**Hinckley & Bosworth Borough Council**  
**Interested Party Reference Number: 20039546**

**Deadline 4 Submission:**

**Application by Tritax Symmetry (Hinckley) Limited for an Order Granting  
Development Consent for the Hinckley National Rail Freight Interchange**

(ref. TR050007)

Para 8.93

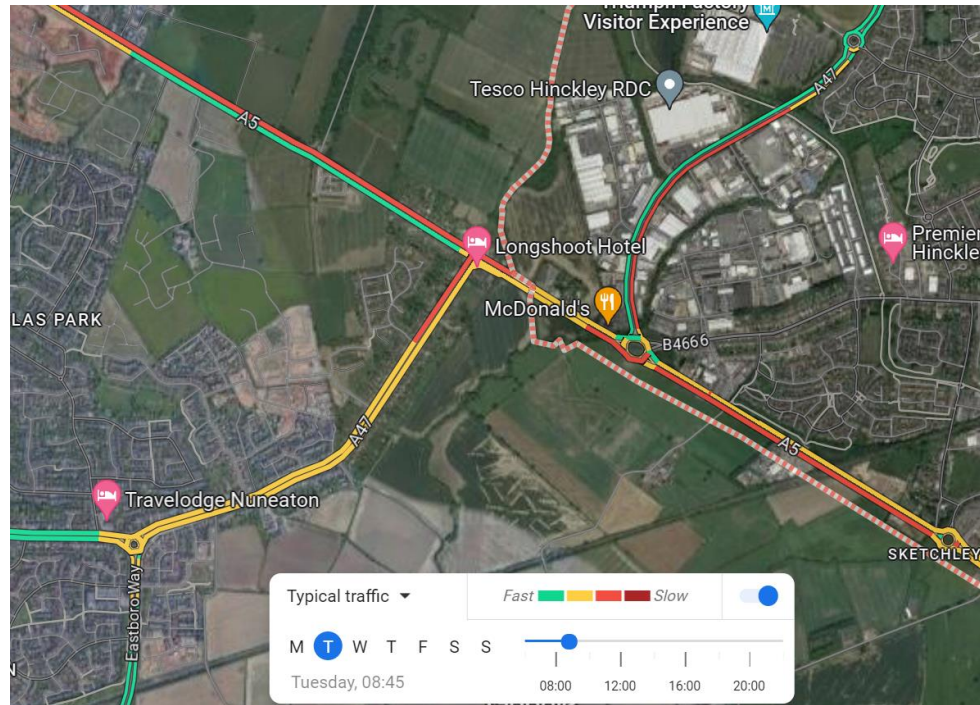
Junction 14 – A5 / B4666 / A47 (Dodwells) – the conclusions that this junction will operate satisfactorily in 2036 without mitigation seems at odds with current practical experience in the peak hours, where extensive queuing and interactions with the adjacent A5/Longshoot junction. The operation of this junction is very important to the Council in that delays here may encourage much higher use of the A47 rather than the A5/M69. The extract from current Googlemap depictions of delay here in a typical morning peak hour is below and shows current issues.
